## ADDENDUM NO. 03

PROJECT: South Orangetown Central School District  
PHASE 1: 2022 BOND

CPL PROJECT NO. 14457.20

DATE: November 9, 2023

Drawing Number  
WOS 1200

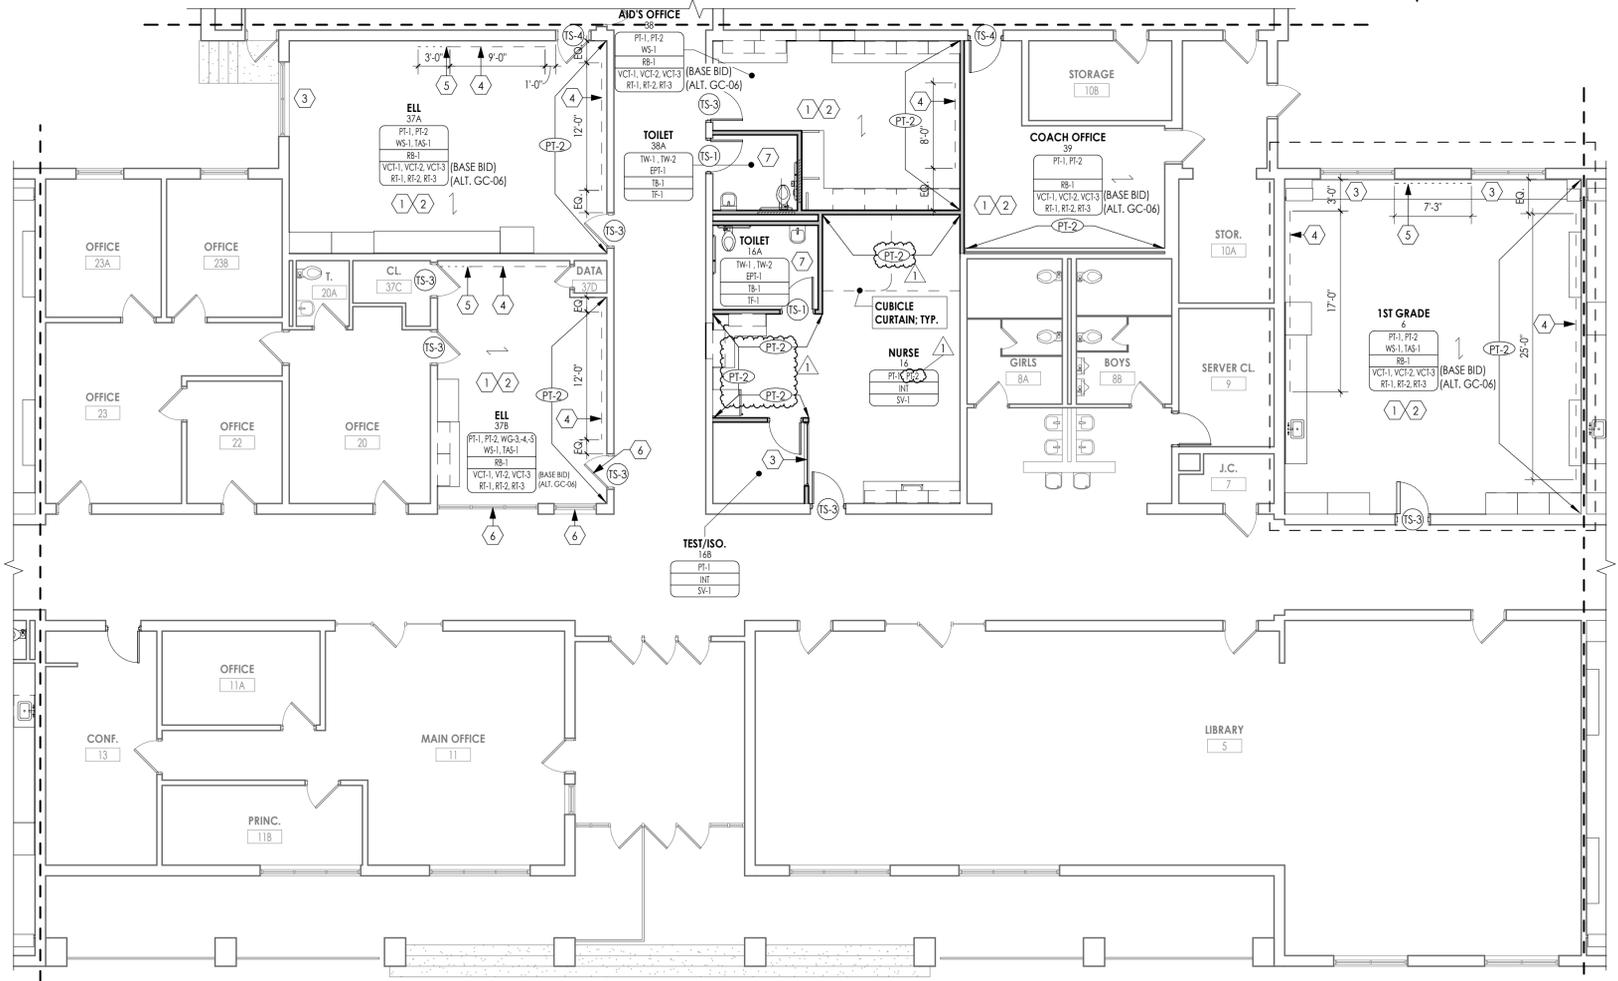
- 4.21 Drawing CLE A901: Replace with attached revised CLE A901
- 4.22 Drawing GEN I000; PAINT (PT) Schedule: Remove row PT-5
- 4.23 Drawing WOS I200: Replace with attached revised WOS I200

Drawing Number  
**WOS E102**

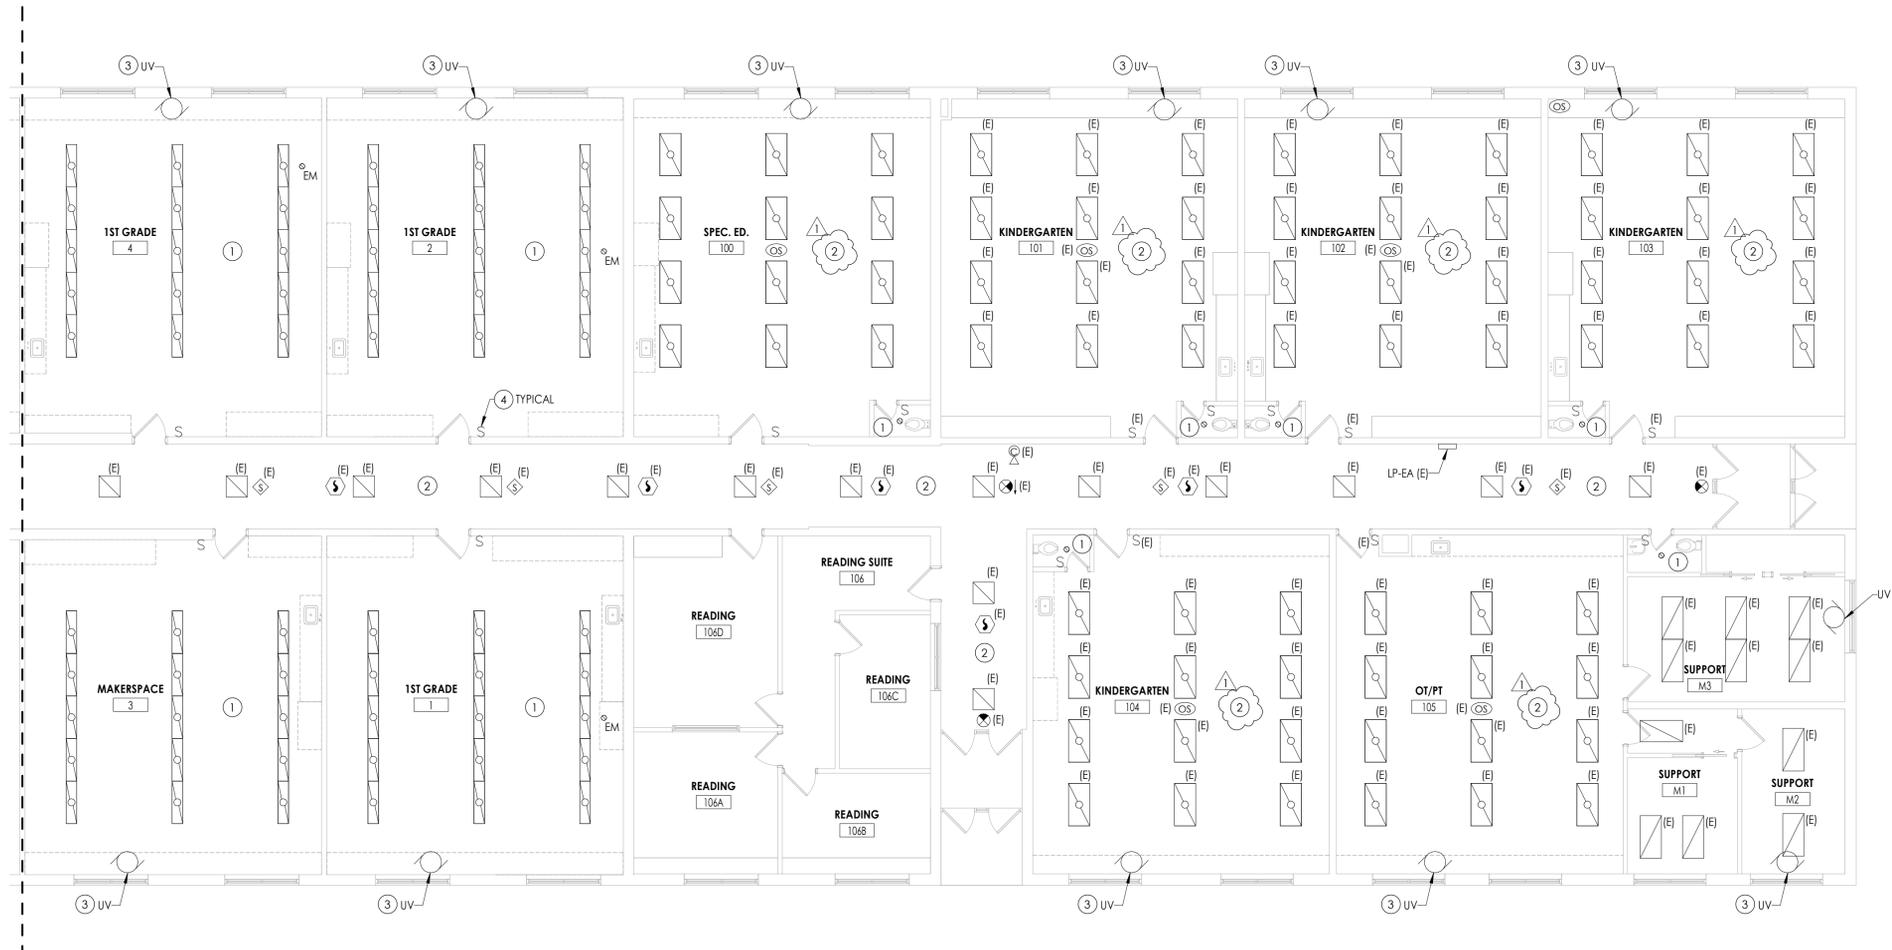
- 4.27 Drawing WOS E102: Replace with attached revised WOS E102
- 4.28 Drawing WOS E103: Revise Keynote 1 to read as follows:  
1. DISCONNECT AND REMOVE EXISTING LIGHT FIXTURES AND ALL CEILING  
MOUNTED DEVICES AS NECESSARY TO ACCOMMODATE ANY CEILING REMOVALS.  
PULL ALL CIRCUITRY BACK TO AN AREA OUTSIDE OF DEMOLITION AND TAG FOR  
RE-USE. REFER TO 300 SERIES DRAWINGS FOR REINSTALLATION LOCATIONS.

Drawing Number  
**CLE E101**

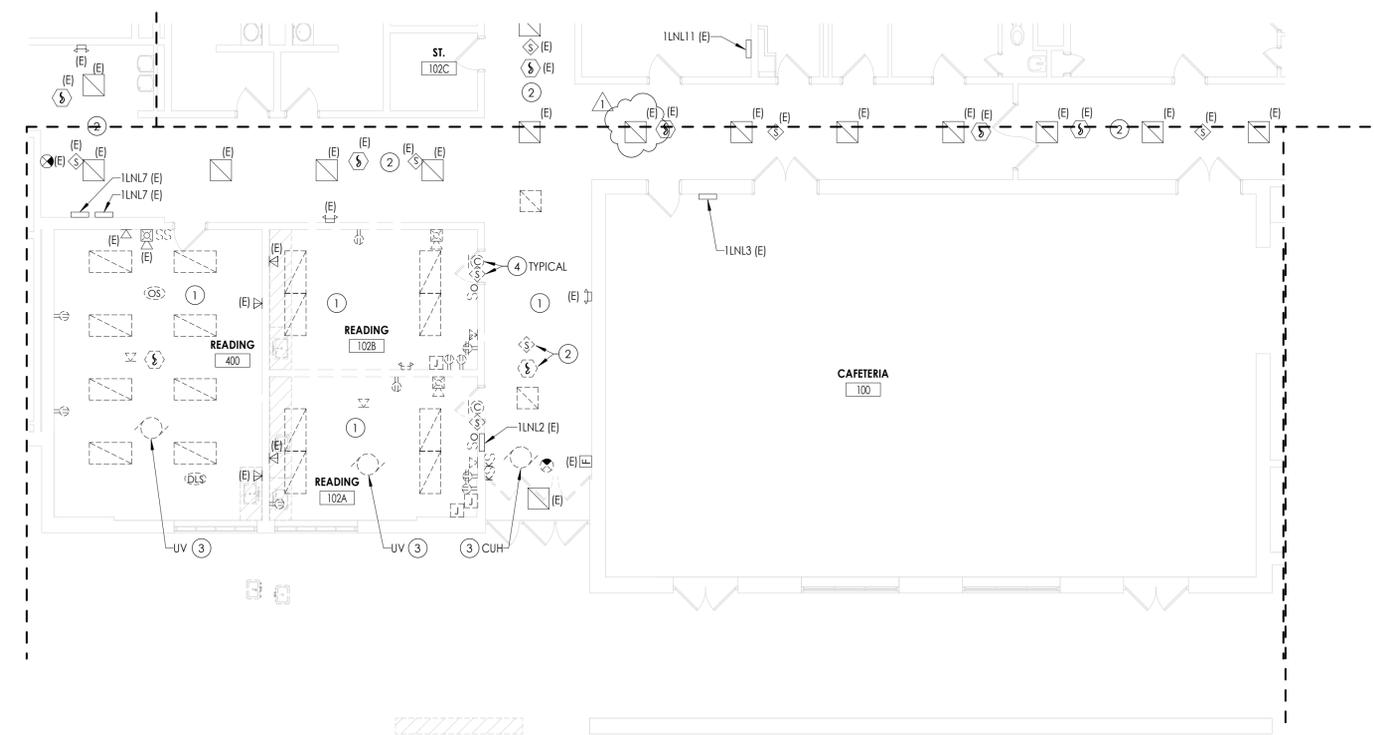
- 4.31 Drawing CLE E101: Replace with attached revised CLE E101
- 4.32 Drawing CLE E102: Replace with attached revised CLE E102
- 4.33 Drawing CLE E103: Replace with attached revised CLE E103

**CLE  
E105**

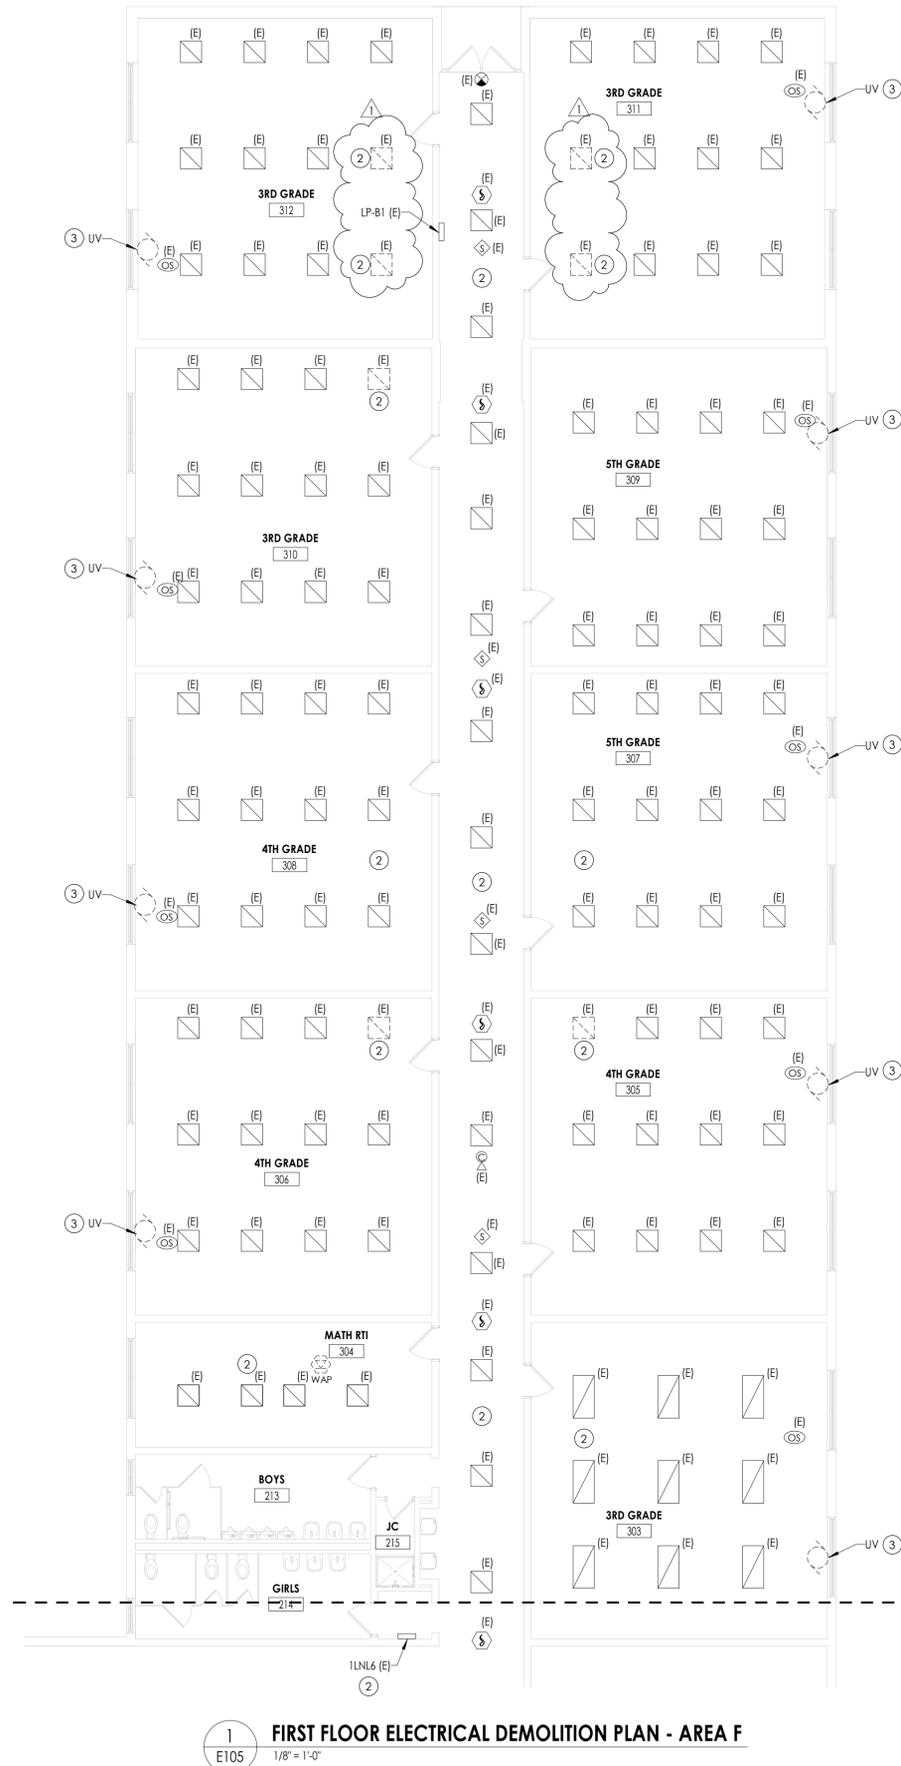
- 4.35 Drawing CLE E105: Replace with attached revised CLE E105
- 4.36 Drawing CLE E203: Replace with attached revised CLE E203
- 4.37 Drawing CLE E301: Replace with attached revised CLE E301

CLE  
E302

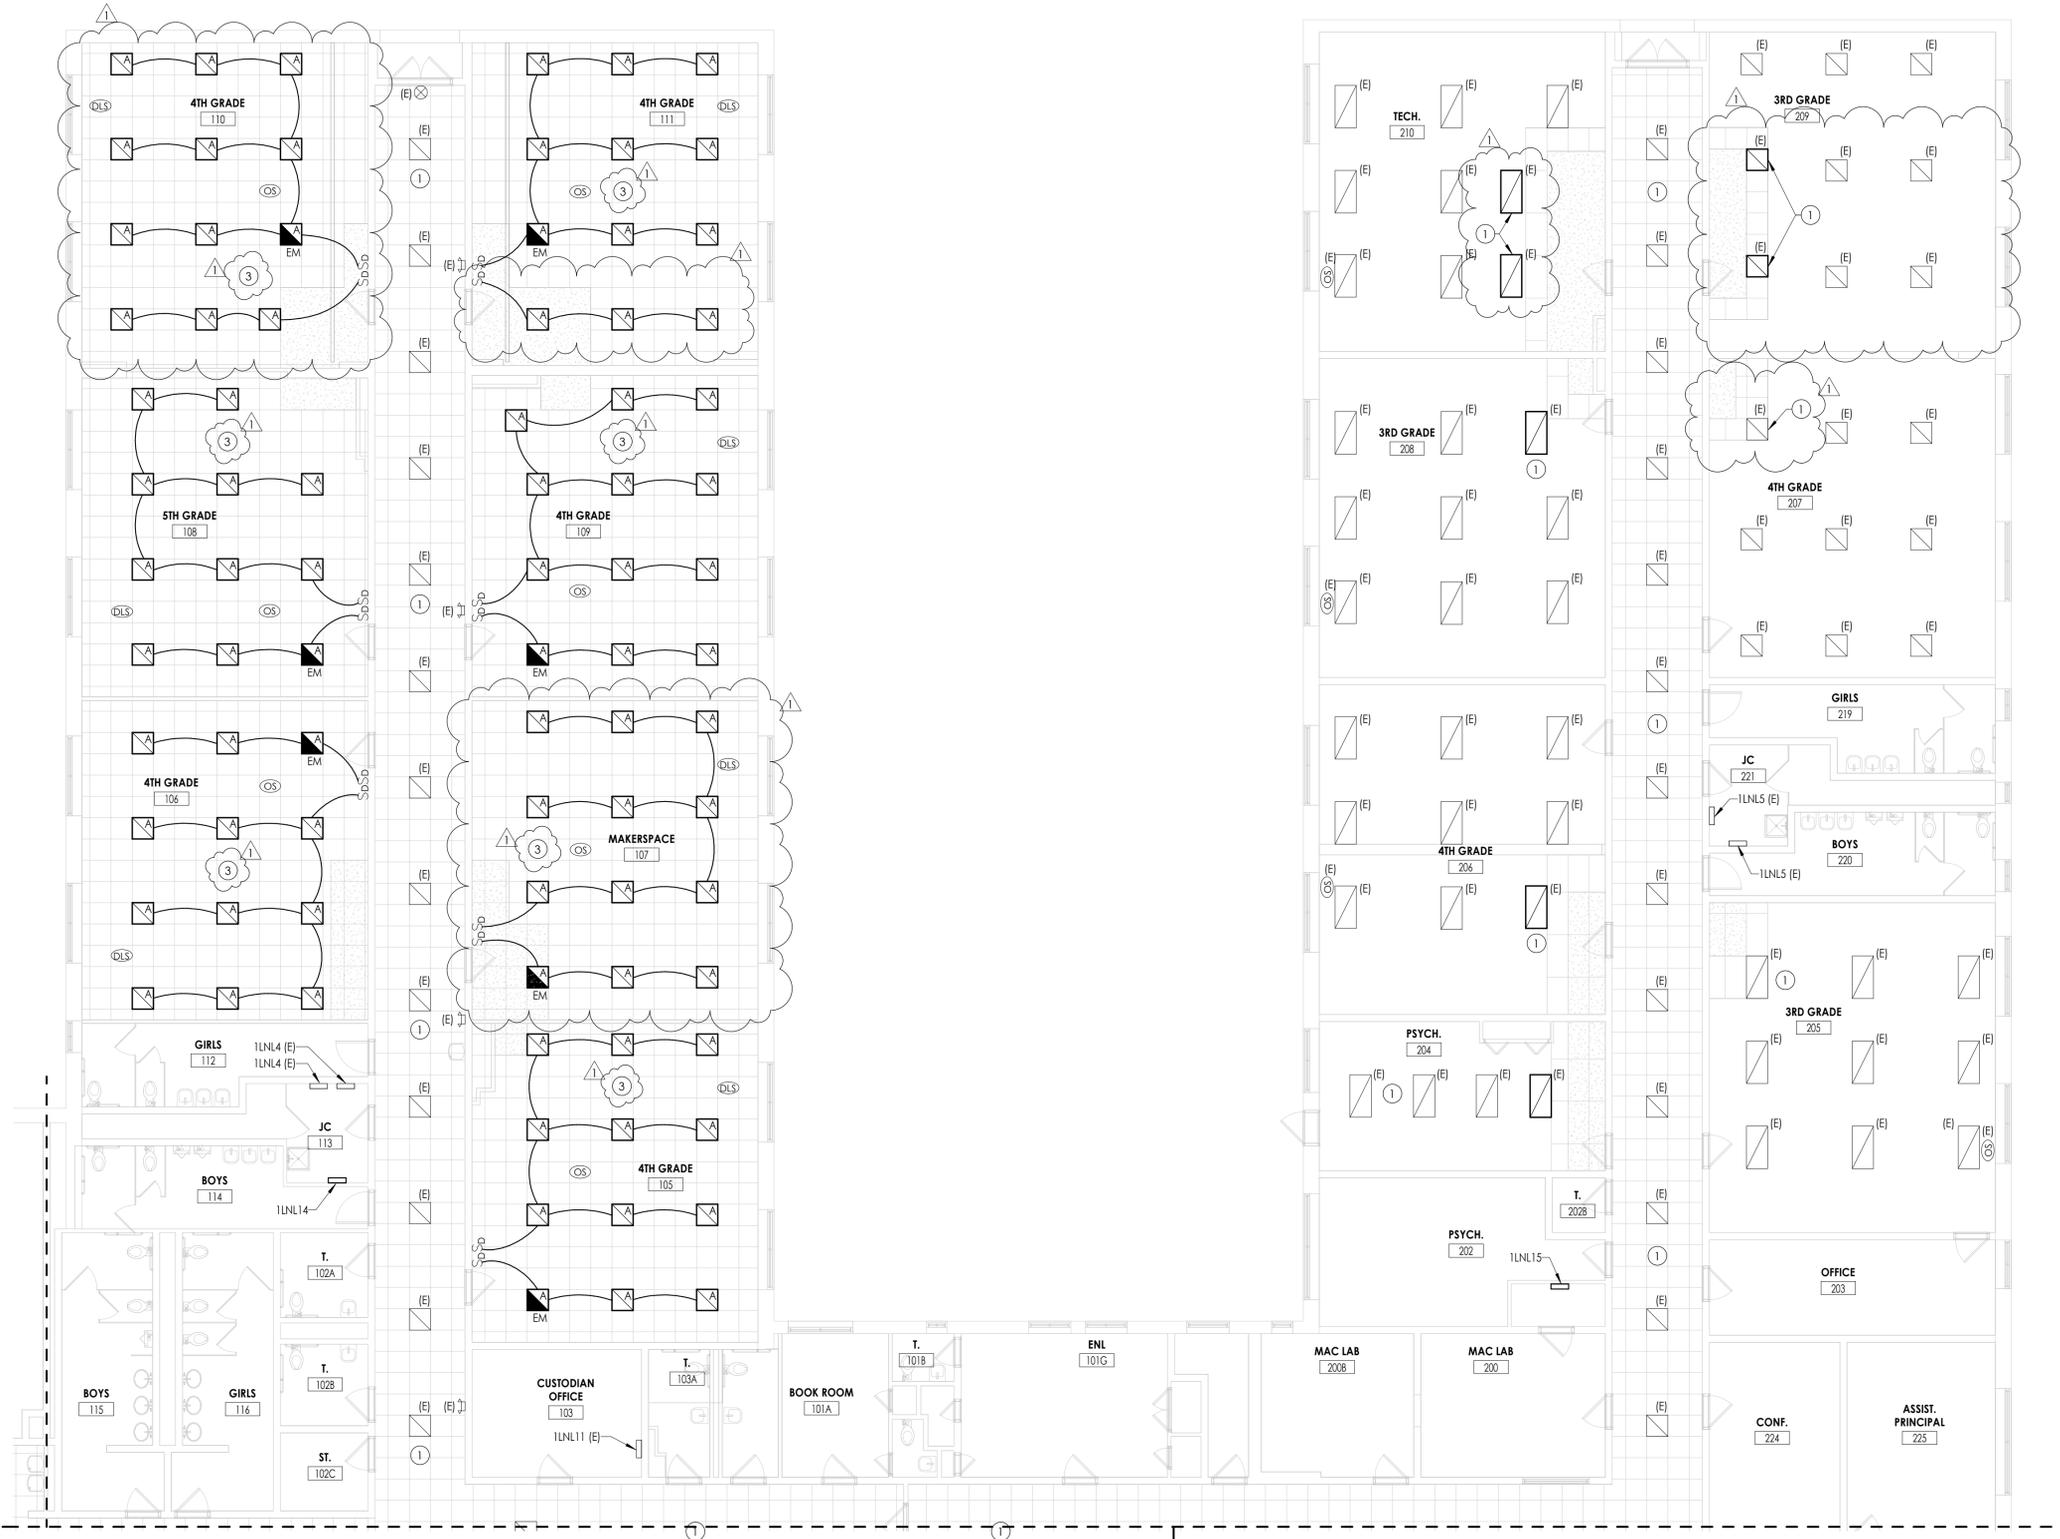
- 4.38 Drawing CLE E302: Replace with attached revised CLE E302
- 4.39 Drawing CLE E303: Replace with attached revised CLE E303
- 4.40 Drawing CLE E304: Replace with attached revised CLE E304
